**ADDENDUM NO. 1
CITY OF BRENTWOOD, MISSOURI**

**ROSE AVENUE PEDESTRIAN IMPROVEMENTS
GBA PROJECT No. 12455**

March 12th, 2013

SUMMARY OF STREET LIGHTING QUANTITIES *

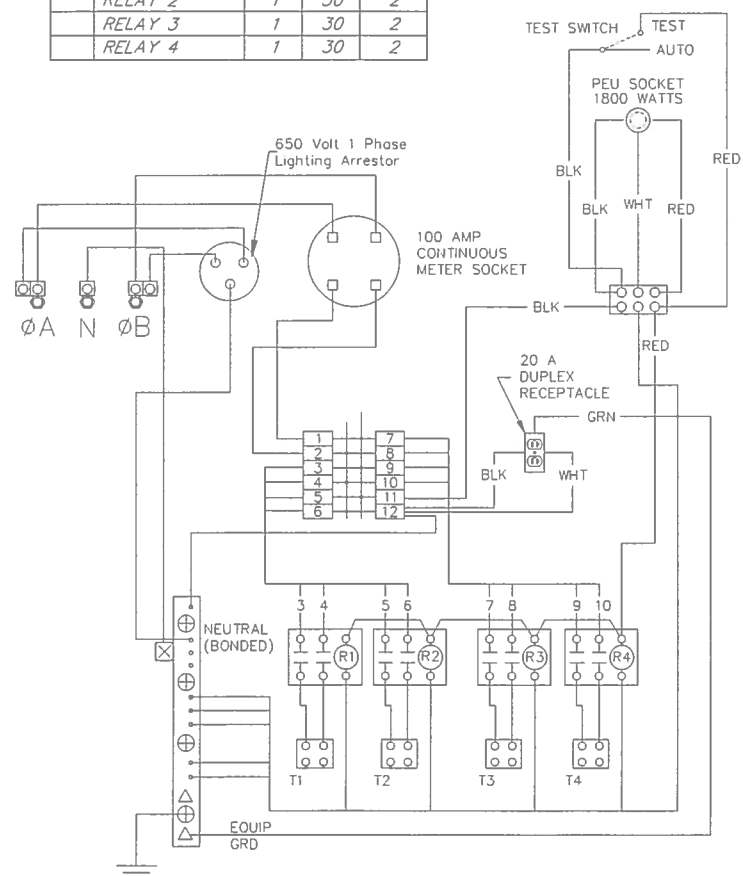
Street Lighting Detail Sheet 1 of 2 has been updated to show the correct "Base, Concrete" quantity, and has changed the pad mounted control center descriptive note to provide a stainless steel enclosure.

BID ITEMS	UNIT	QUANTITY
10' 4210-FP4 AUGUSTA SERIES 4" OD FLUTED POLE	EACH	18
150 WATT MH A880 TOWN SQUARE SERIES ACORN FIXTURE	EACH	18
175 WATT METAL HALIDE LUMINAIRE (TYPE III DIST.)	EACH	18
GROUND ROD**	EACH	18
BASE, CONCRETE	CY	8.0
TYPE I JUNCTION BOX	EACH	5
TYPE II JUNCTION BOX	EACH	3
CONTROL CENTER - PAD MOUNTED	EACH	1
CONTROL CENTER FOUNDATION	EACH	1
CONTROL CENTER GROUND ROD	EACH	1
CONDUIT, 2 IN., PUSHED	LN. FT.	1550
CONDUIT, 3 IN. RIGID, PUSHED	LN. FT.	150
CONDUIT, 2 IN. RIGID, EXTERNAL ON STRUCTURE	LN. FT.	100
CABLE, 6 AWG 1 CONDUCTOR	LN. FT.	5020
CABLE, 10 AWG 1 CONDUCTOR, POLE AND BRACKET	LN. FT.	400
CABLE, 2 AWG 1 CONDUCTOR	LN. FT.	50
CONNECTOR KIT, FUSED**	EACH	36
CONNECTOR KIT, UNFUSED**	EACH	18
FARGO CONNECTORS**	EACH	54
